July 18, 2025

In response to your request to review the validity of the conclusions of the 2025 WLNG summary memo titled, “*Henriette Lake Dam Wave Modelling Summary*” this document provides my comments as an independent consultant with dam breach experience. There is also background provided on the limitations of river modelling software used for other purposes such as estimation of ocean impact wave heights.

Figure A) NHC Figure 22 of Flood Wave overlain on Stantec Figure of Floatel Locations

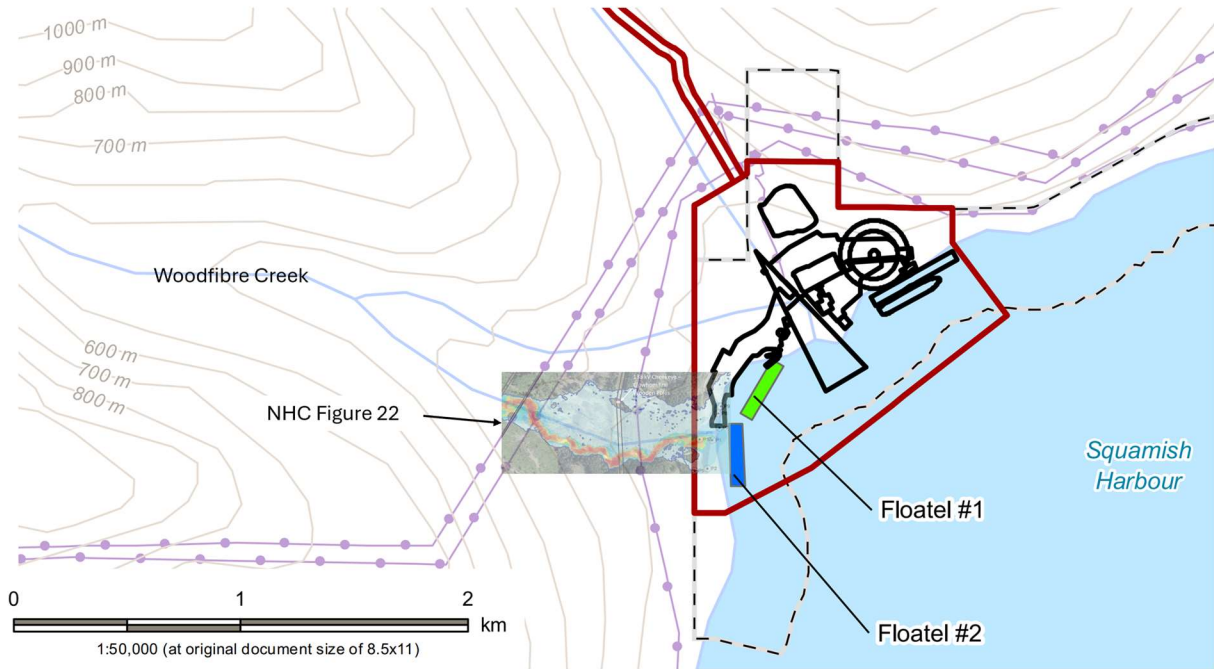
Figure 22 of the NHC 2022 report shows river modelling flow heights diminishing as they are extrapolated out into the area of the Woodfibre foreshore immediately adjacent to where the present floatel is now moored. It is not clear if water levels derived from a river flood model are appropriate to show in the ocean where wave propagation dominates, not water level effects. As the low flood water level heights seen in the NHC river model figure at the ocean water’s edge show, you cannot “flood” the ocean, but you can certainly create large, damaging waves there that propagate long distances on the ocean surface.

The memo neglects to indicate the location of either the present floatel or the proposed location of floatel #2 which also makes it difficult to assess the validity of the comments about wave attenuation as distance is a key factor in attenuation. Figure A) based on a Stantec figure, shows that floatel#2 would be immediately adjacent to the mouth of Woodfibre Creek. Based on the scale of the figure, floatel#2 would be at approximately 20 m to 40 m from shore.

The main concern about the memo is whether the summary comment that states “waves will be rapidly attenuated” is based on valid wave propagation modelling, or is the comment simply based on a simple visual assessment of Figure 22 made by NHC that may not be valid at all in the area of the ocean.

After: Figure 22 NHC Report: Maximum Incremental Flow Depths along Downstream End of Woodfibre Creek

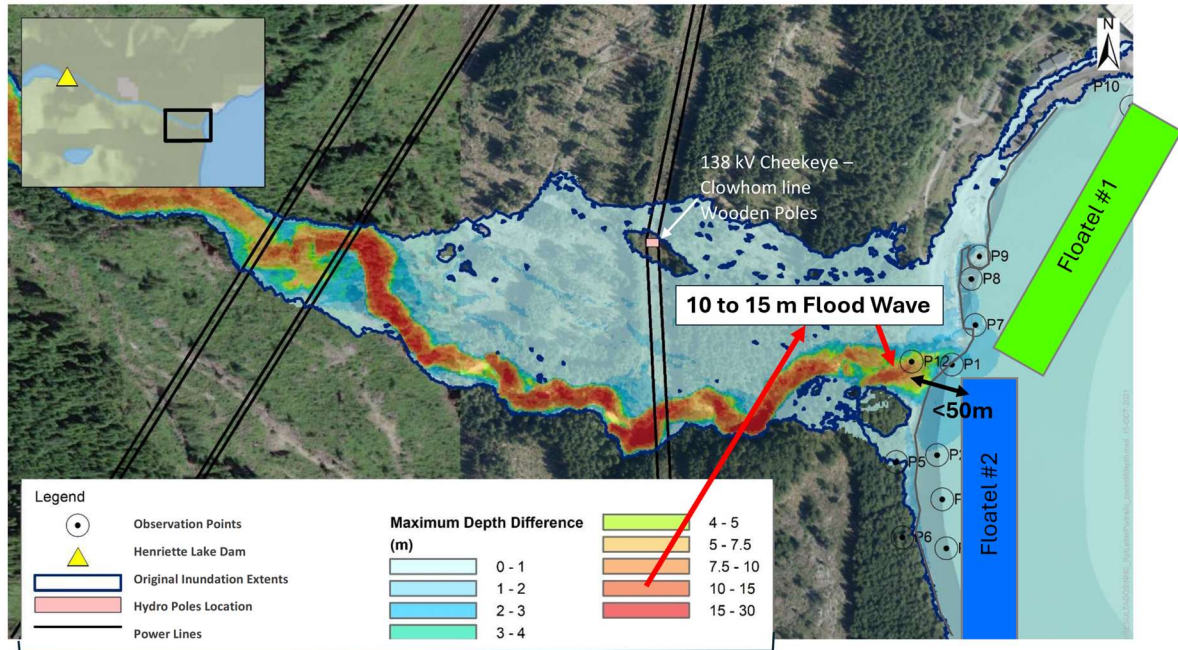
Modelling of waves in the open ocean is not what HEC-RAS2 is designed for. It is thus not surprising that its output figure (NHC Figure 22) would show rapid loss of wave height due to loss of confinement upon exiting the creek mouth. However, the slug of water from the dam breach wave that NHC modelled as being 10 m to 15 m high and moving at 6 m/s or more, will certainly not attenuate in short distances and would simply continue into the ocean under its own momentum. Once this slug of water traverses the beach section (in a few seconds at 6 m/s) and crosses into deep enough water, the large ocean waves expected to be generated by the momentum of the slug would not dissipate rapidly (on the ocean free surface waves can travel many miles).

As a simplification and rule of thumb, it is often assumed that persistent ocean waves cannot be sustained that are higher than the water depth. However, the momentum of large wavefronts such as a 15 m high slug of rapidly moving dam breach water can traverse a region of shallow water with little attenuation and generate a large ocean wave once deeper water is reached. Figure B shows the proximity of floatel #2 to the NHC region modelled with 10 m to 15 m high flood waves from a dam breach.

**Figure B) Approximate floatel locations added to NHC Figure 22 (based on locations in Stantec Figure)**
